FINAL PLAT OF
"MARIE'S MEADOW"
SEDGWICK COUNTY, KANSAS
IN THE NORTHWEST QUARTER OF SECTION 4,
TOWNSHIP 28 SOUTH, RANGE 2 WEST OF THE 6TH P.M.

RE: SUB 2003-20 -- One-Step Final Plat of Le' Marie Addition

RE: SUB 2003-20 -- One-Step Final Plat of Le' Marie Estates Addition

CASE NUMBER: SUB 2003-20 -- LE' MARIE ESTATES

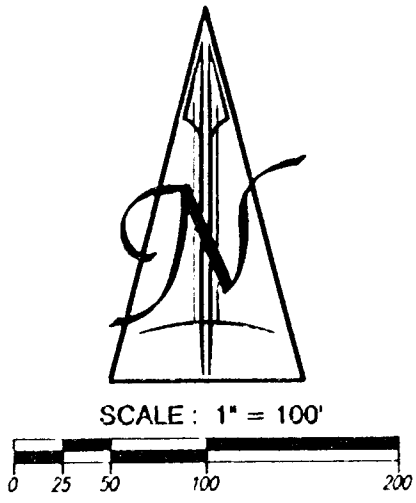
- E. **County Engineering** needs to comment on the status of the applicant's drainage concept. *A drainage plan is needed. The drainage plan needs to address effect of terraces. A flood study is needed. Minimum pads need to be set for lots 9 through 15, based on flood study.*

- F. **County Engineering** needs to comment on the access controls. The plat denotes complete access control to 23rd St. for Lots 1 and 14. *Access control except one opening shall be dedicated for Lot 15. Complete access control is needed along the north 75 feet of the west line of lot 1 and the north 75 feet of the east line of Lot 14.*

- I. County Fire Department/County Engineering needs to comment on the street length of the proposed cul-de-sac (2,300 feet). Rural cul-de-sacs over 1,200 feet in length must provide a stub street connection or contingent street dedication providing future access to adjoining tracts, or an emergency access easement. **A contingent street dedication is needed between Lots 7 and 8.**

- J. County Engineering requests a contingent dedication of street right-of-way between Lots 7 & 8 in order to provide potential street connection to adjoining properties. On the final plat, the contingent dedication of right-of-way needs to be referenced in the plattor's text.

- K. The drainage easement between Lots 8 & 9 should be increased to 40 feet.
- L. The applicant is reminded that this site is located within three miles of the City Limits of Wichita and will be heard by City Council. Therefore, the City Council signature block needs to be included on the final plat.

- O. The applicant needs to assign a name for the new street. **Leo Circle will be the street name.**
- P. The floodway reserve within Lot 15 shall be denoted by a dashed line.
